Re: The Hub at Tucson III (No. T17SA00305) – March 2018 Design Package Changes

THE HUB AT TUCSON III

DESIGN PACKAGE - CHANGE SUBMISSION I **CHANGES TO OCTOBER 3, 2017 APPROVED DESIGN**

1 WEST ELEVATION
1/16" = 1'-0"

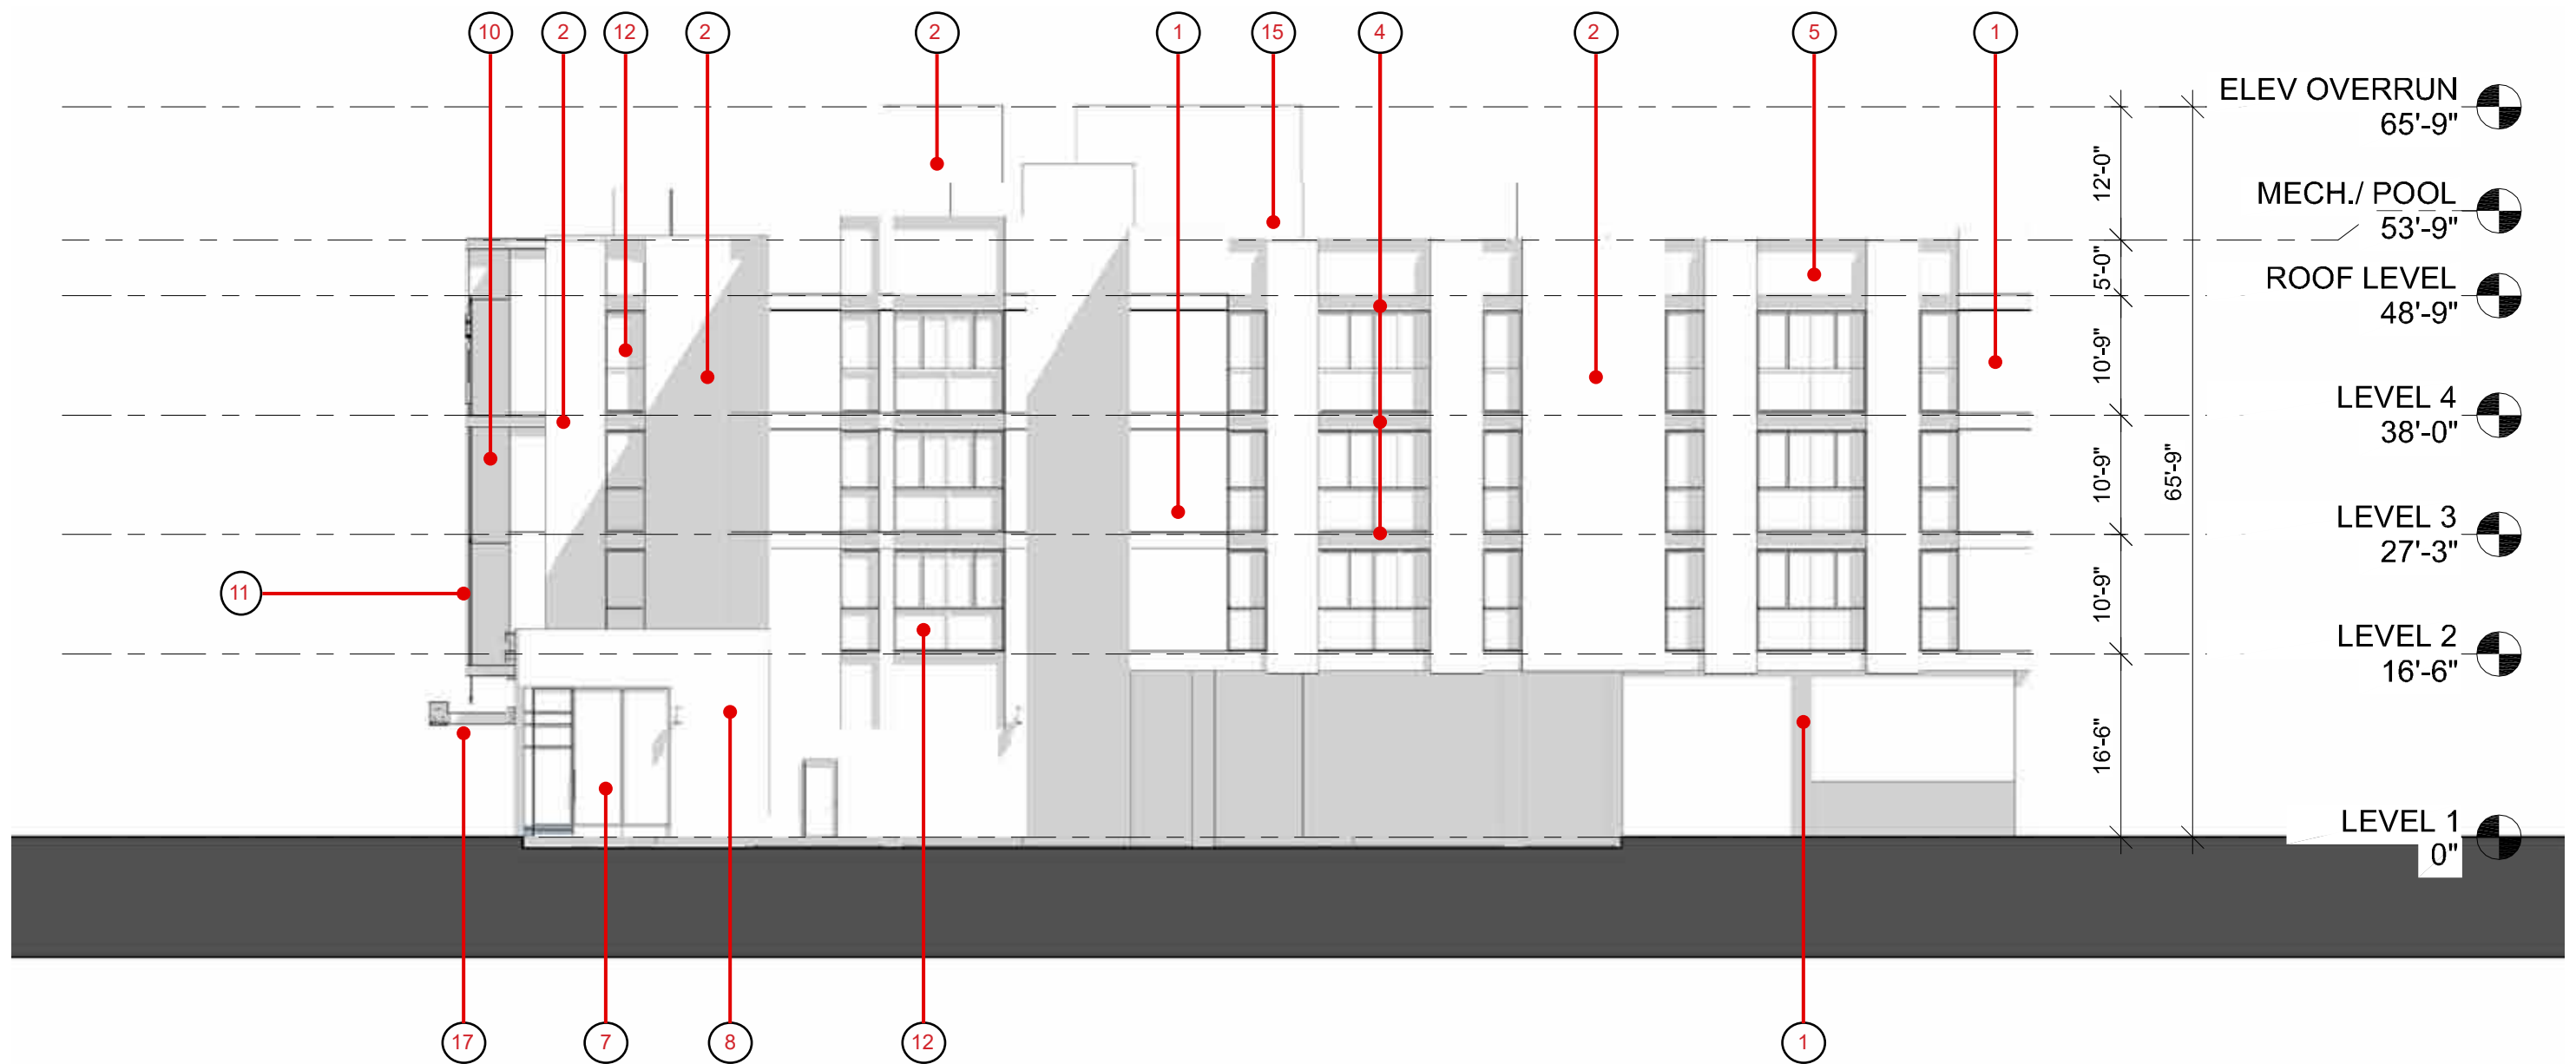
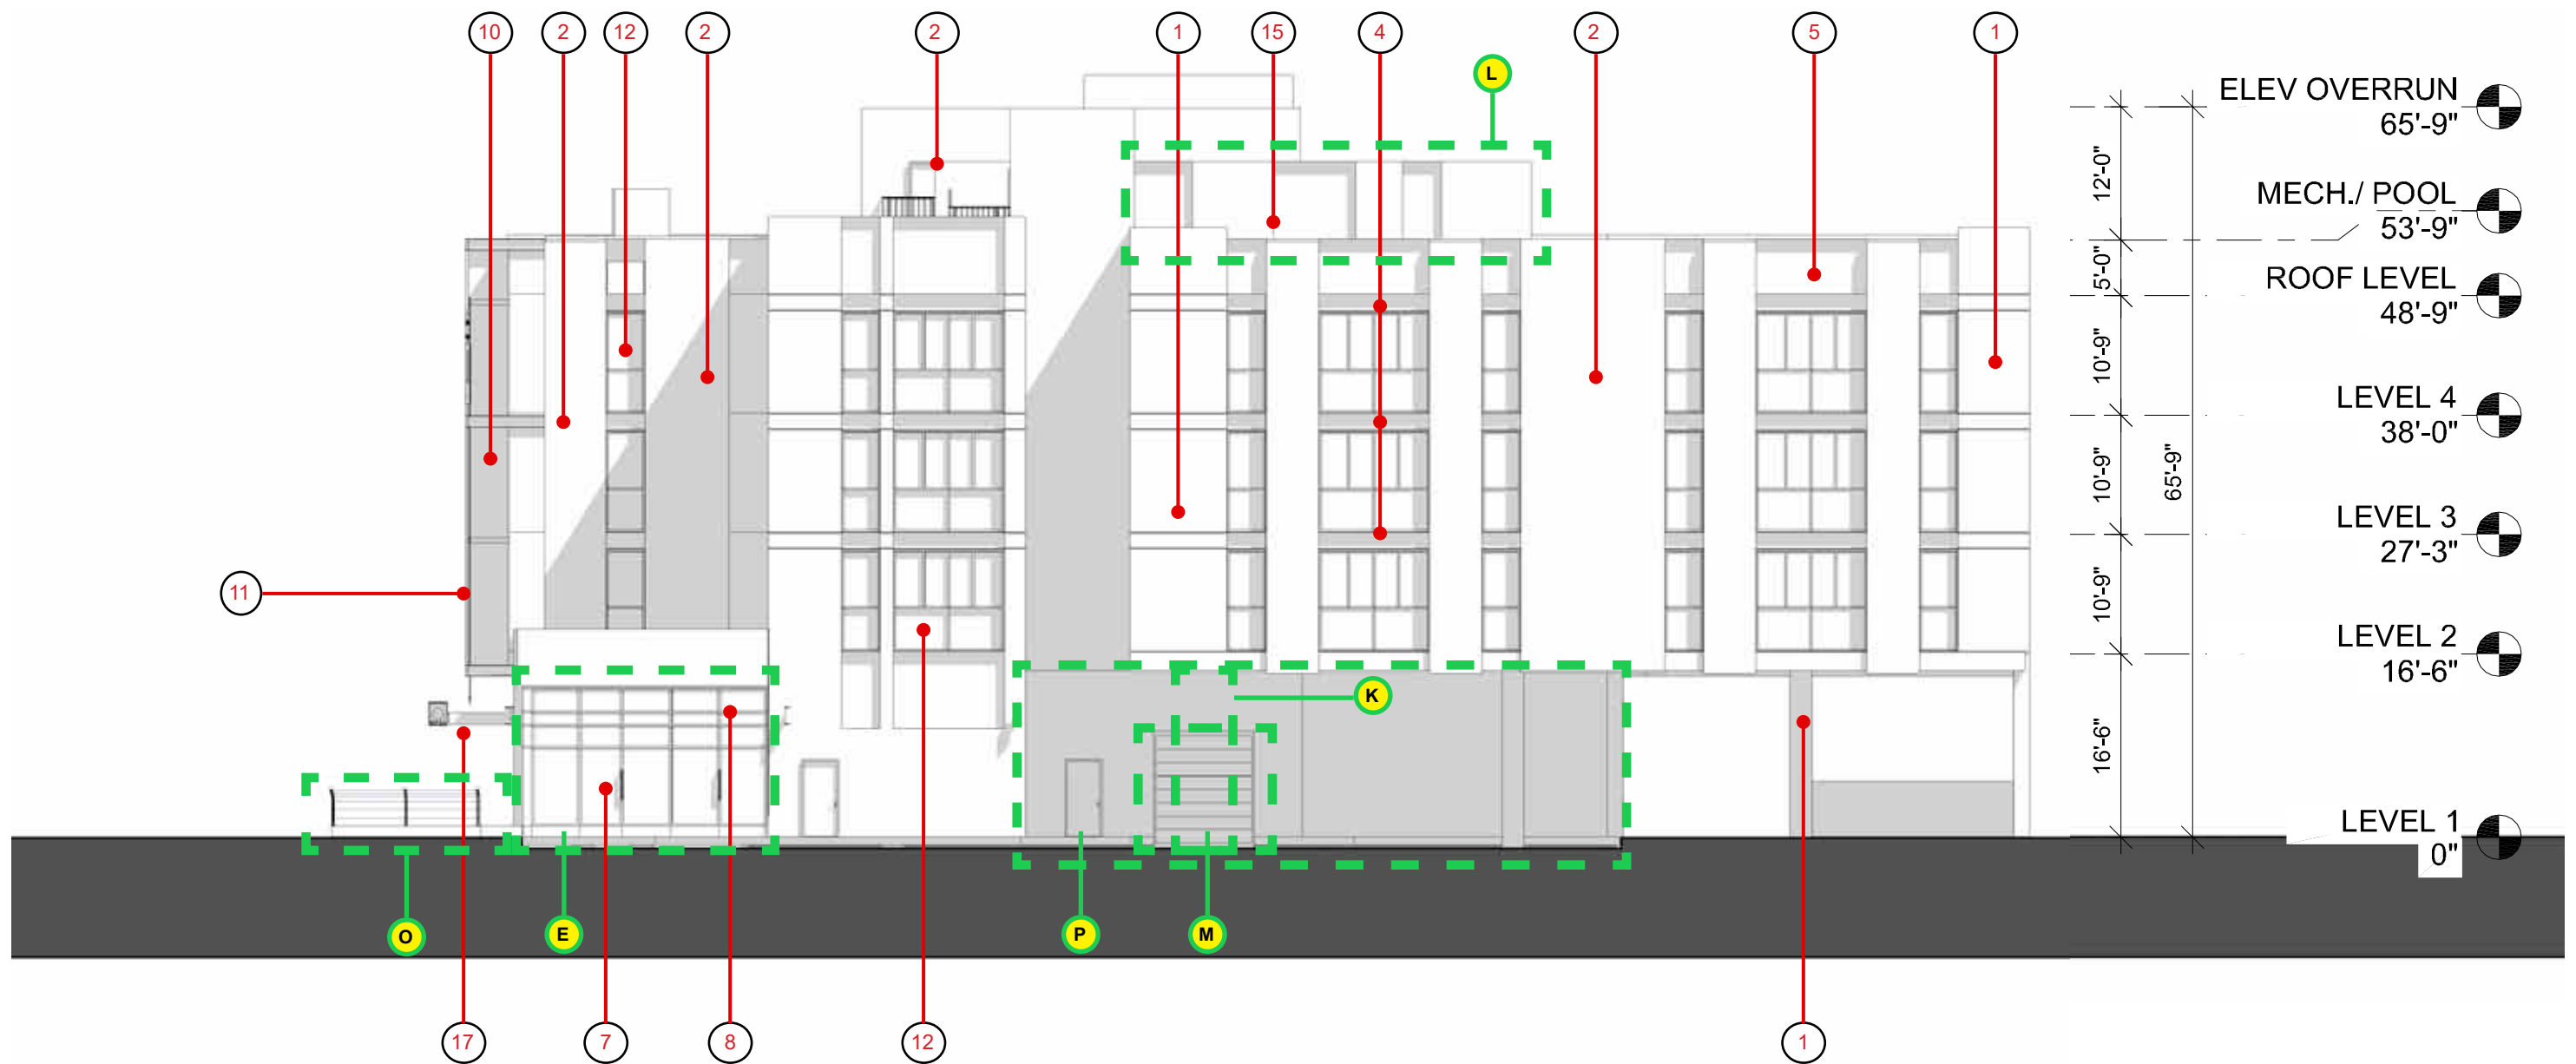
WEST ELEVATION

E,K,L,M,P

5. Transformer Enclosure Gate Expanded (Item E): The access gate to the transformer enclosure at the Project’s northwest corner (“Transformer”) has been expanded to allow for two access doors. The Transformer area will contain two pieces of equipment (transformer and PME cabinet), each requiring a 10-foot access gate. The additional access door addresses the unforeseen need to allow for additional access space for both

11. Loading Area Column Removed (Item K): The original design included a support column at the north end of the loading area. Upon further study, there is no structural need for this column and it has been removed. The column had no significant design value as it was located in the alley and away from view. Removing the column is a response to an unforeseen circumstance, and its elimination has little if any impact on the Project's design.

13. Service Door Added at Alley (Item M): The reconfiguration of the Project's first floor layout resulted in the addition of a service door on the alley. This is a response to an unforeseen circumstance, and will improve the internal functionality of the Project. The service door is an appropriate addition to the alley, and does not have a significant impact on the Project's design.

16. Alley Façade Changes (Item P): The Alley façade has changed slightly due to interior building changes and design improvements. The original Design Package did not show an emergency exit door leading to the Alley, and so this Submission corrects this. In addition, the corrugated panel system that extended to the Alley floor has been replaced at street level with the smooth natural gray finish found on other parts of the Project. This is done mainly to improve maintenance in this area, as the smooth gray finish will be easier to maintain than the corrugated finish. This change incorporates existing materials used elsewhere on the building, and is done in an area only visible from the Alley. As a result this is a minor design change.
